Questions regarding intakes and tunnels as presented

Nicole S. Suard, Esq. for Snug Harbor Resorts, LLC

N. Suard, Esq. for Snug Harbor Resorts, LLC
re: tunnel construction impacts

Figure 1: TDF Project Location

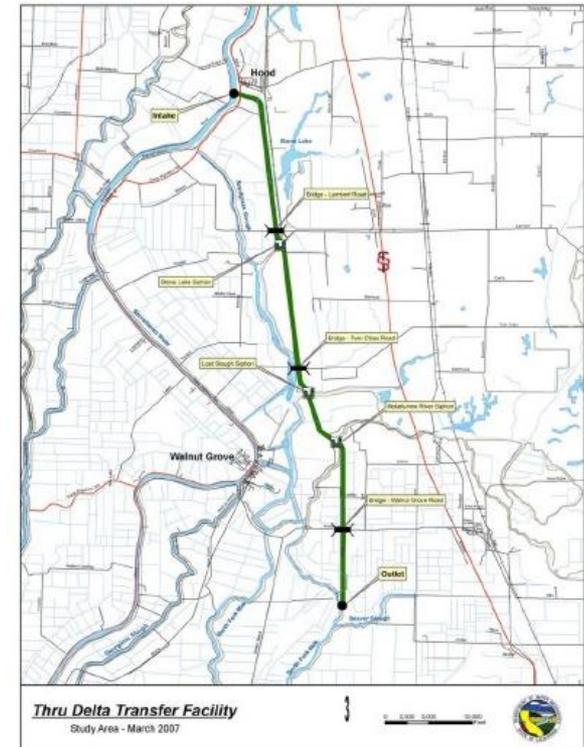
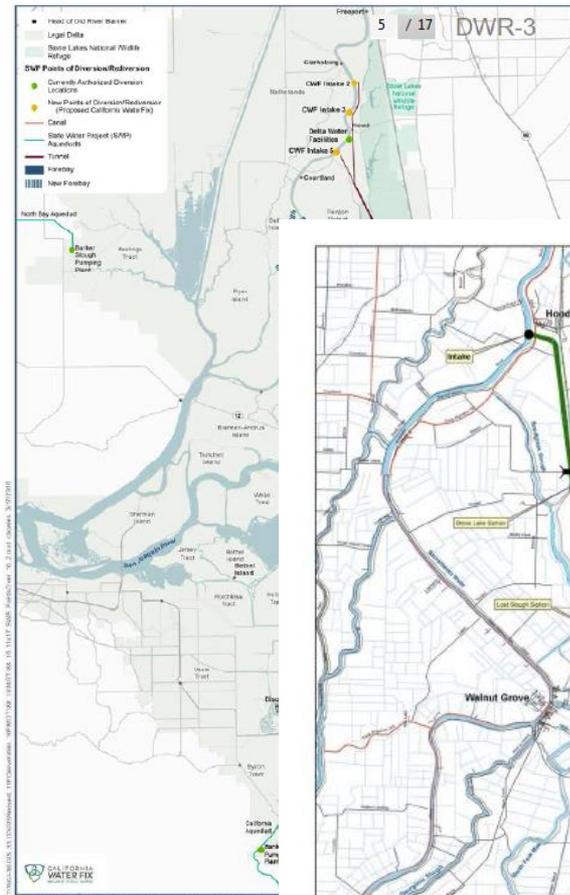
1. Existing authorized point of diversion is shown on the map as between intakes 2 and 3. Is that a 1,350 cfs capacity intake? Is it anticipated that when there is sufficient flow on the Sacramento River the full 10,350 cfs under all four permits would be taken from the Sacramento River?

PHYSICAL COMPONENTS OF THE PROJECT

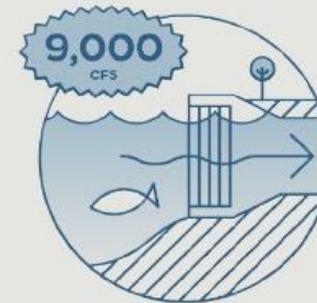
1. 1 cfs = 1.98 acre feet per day estimated. $9000 \text{ cfs} \times 1.98 = 17,820 \text{ af per day}$, which equals 6,504,300 acre feet per year, so why the average yield of 4.9 million acre-feet? Does it take diversion of 6.5 maf to deliver 4.9 maf?
2. Will there be overflow or pressure relief valves and if so where does that water go? Is MAXIMUM capacity for each intake 3000 cfs or is each designed to be adaptable to accept extra capacity? What is the diameter of each smaller tunnel or pipes, and the total number of tunnels or pipes, from each intake structure to the 40 foot tunnels?
3. Will those smaller tunnels or pipes be located at the bottom of the river, mid-river or near the surface?
4. What is the capacity of each 40 foot tunnel? In cfs and in acre feet?

MAIN TUNNELS

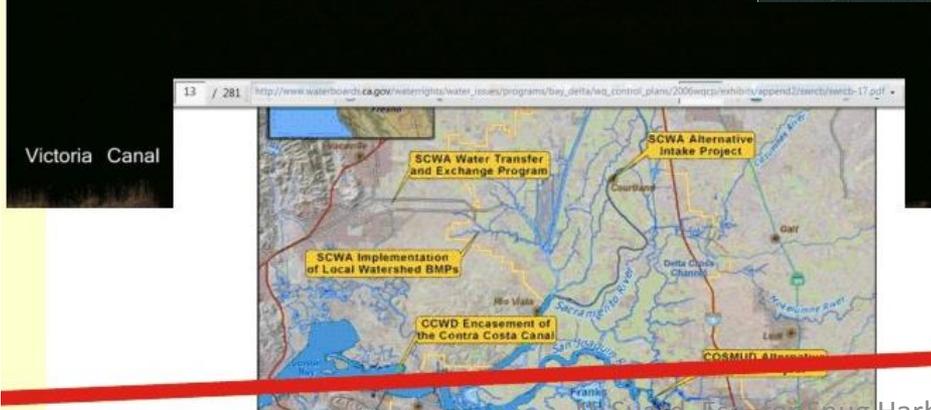
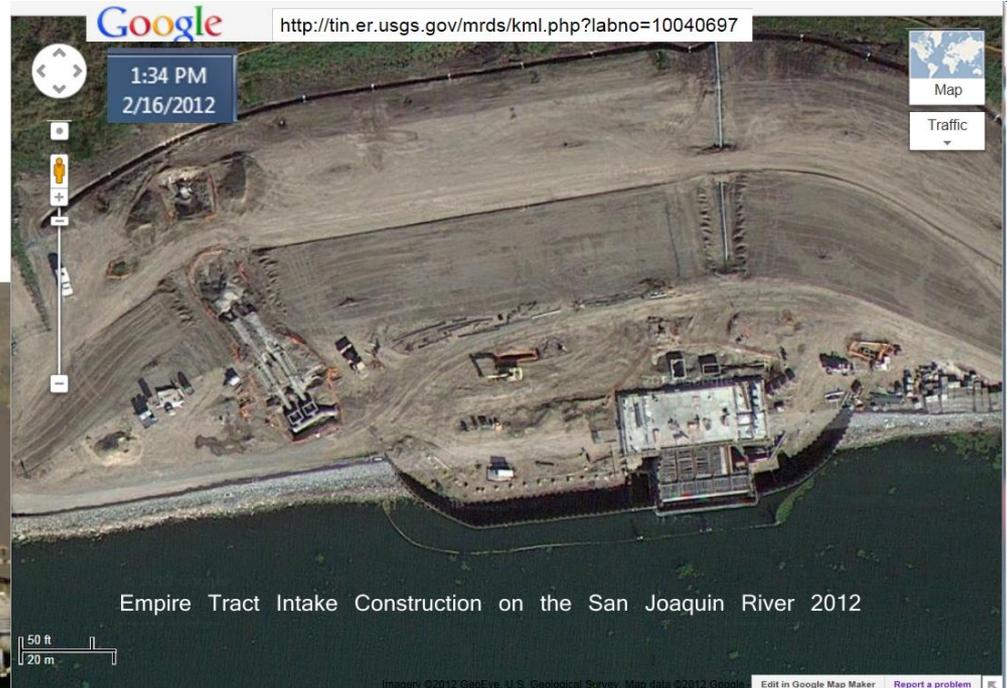
Tunnels and shafts have already been constructed in the Delta region. Were these projects reviewed to give the engineering team an idea of what they might expect to happen?

9,000 CFS GRAVITY SYSTEM

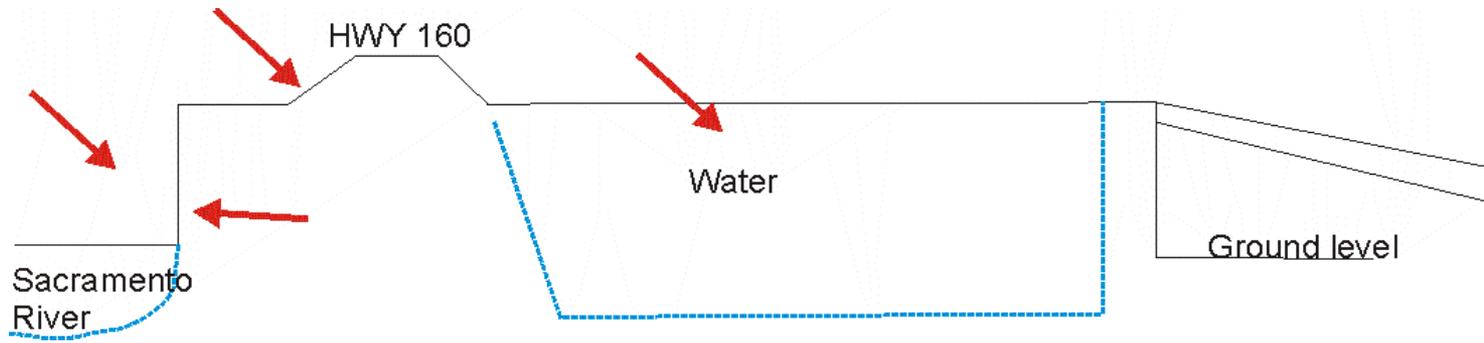
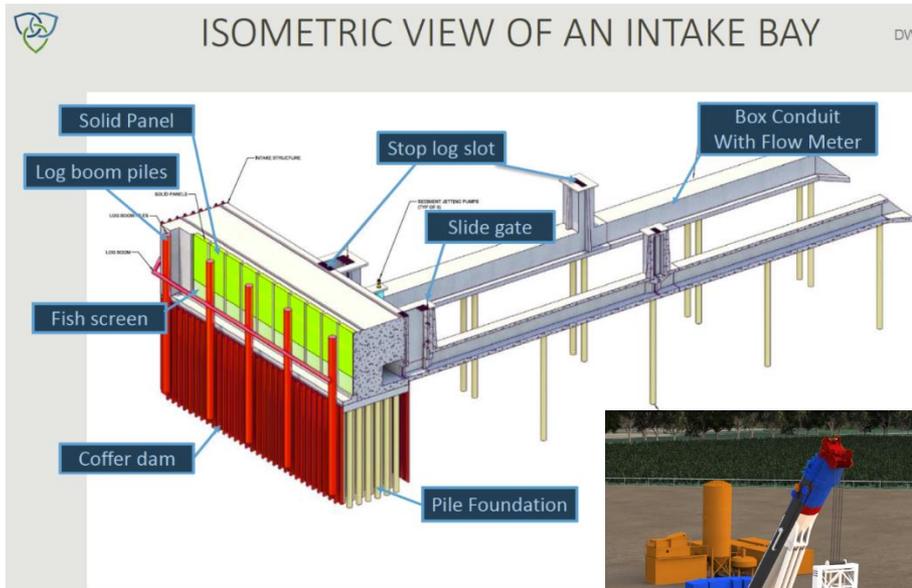
Where is a detailed side profile for the intakes and tunnels?

Compared to the existing HWY 160, How much higher, in feet, will the Profile of the intake structure be and How much higher will be the new levee And HWY 160?

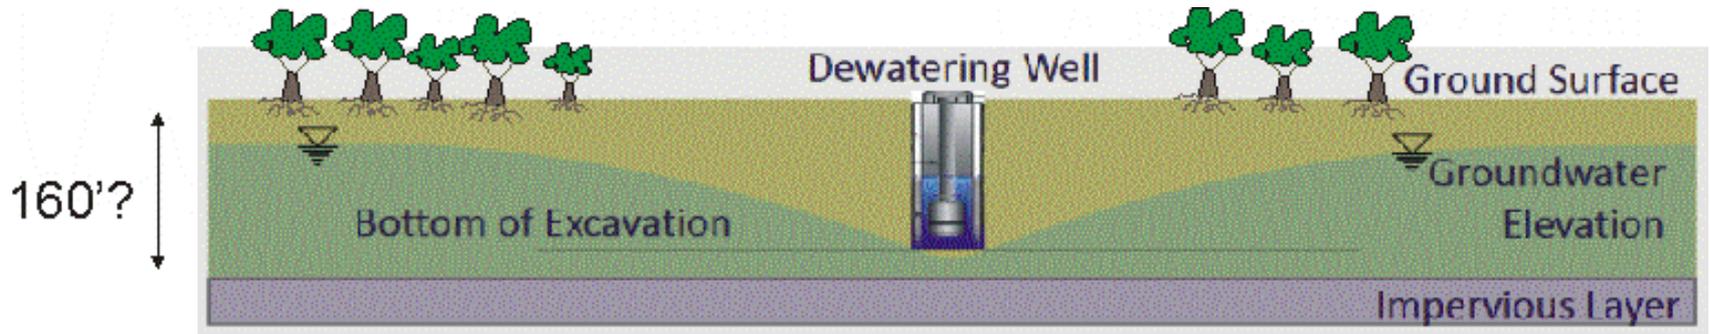
Does water drop 150 feet into tunnels, get pumped up to forebay then dropped again 150 feet or is the tunnel shallow at the intakes and gradually slopes downward to create gravity feed?

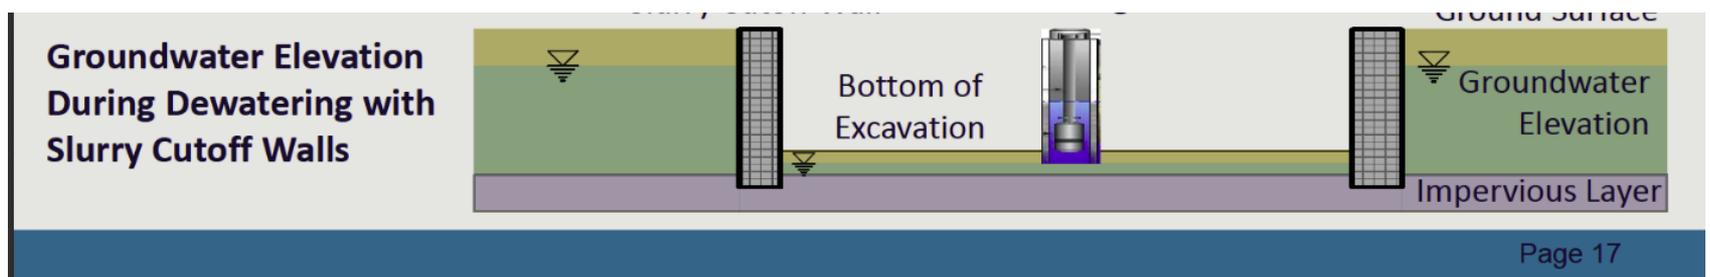
Dewatering will potentially eliminate the water source for area trees which have relied on groundwater during dry periods for their entire existence. How long will the trees in the area survive without root access to groundwater? Or is there a plan to water the trees during the time period of dewatering the ground?

Figure 4-21. Plan View of the Proposed Gate Structure at Threemile Slough

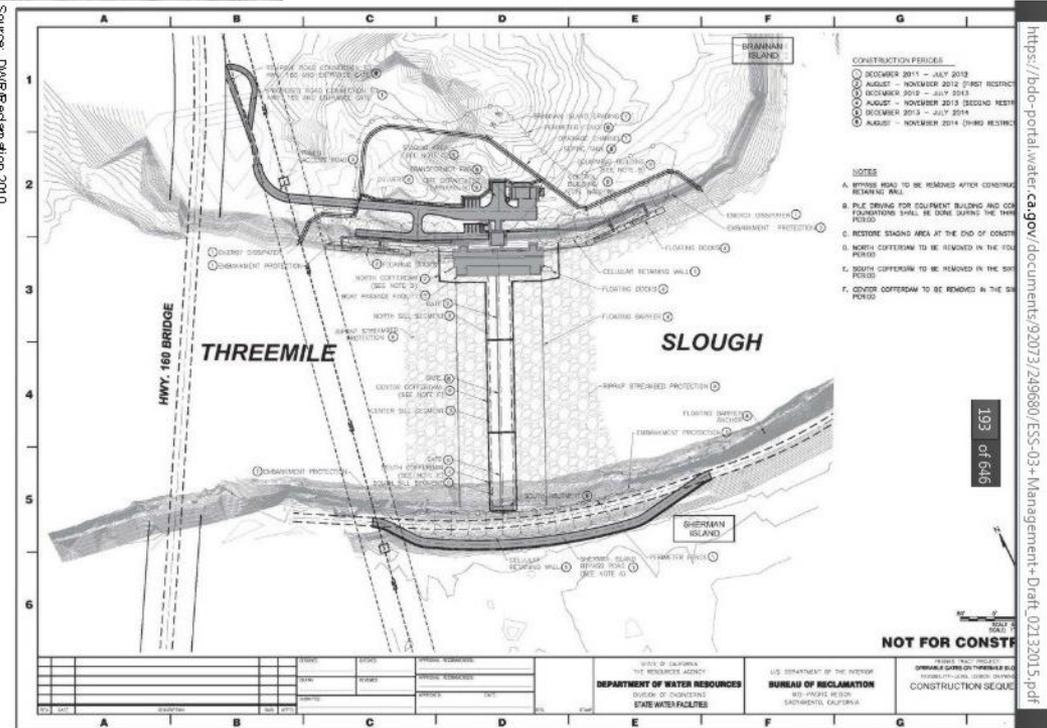
USBR (2015) already went through the process to install flow and fish barrier on 3-Mile Slough. Was this considered in the design and location of the tunnels? (2008 Blue Ribbon Task Force presentation & 2016 USBR

Figure 2-2
Illustration of Bottom-Hinged Gate Operation

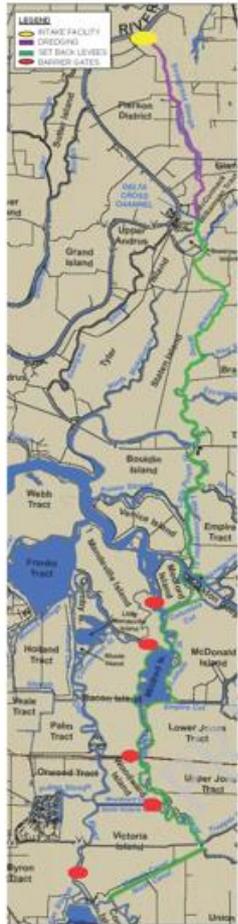
Have these types of barriers been installed anywhere in the Delta? If not, why not try it instead of permanent barrier at Head of Old River?
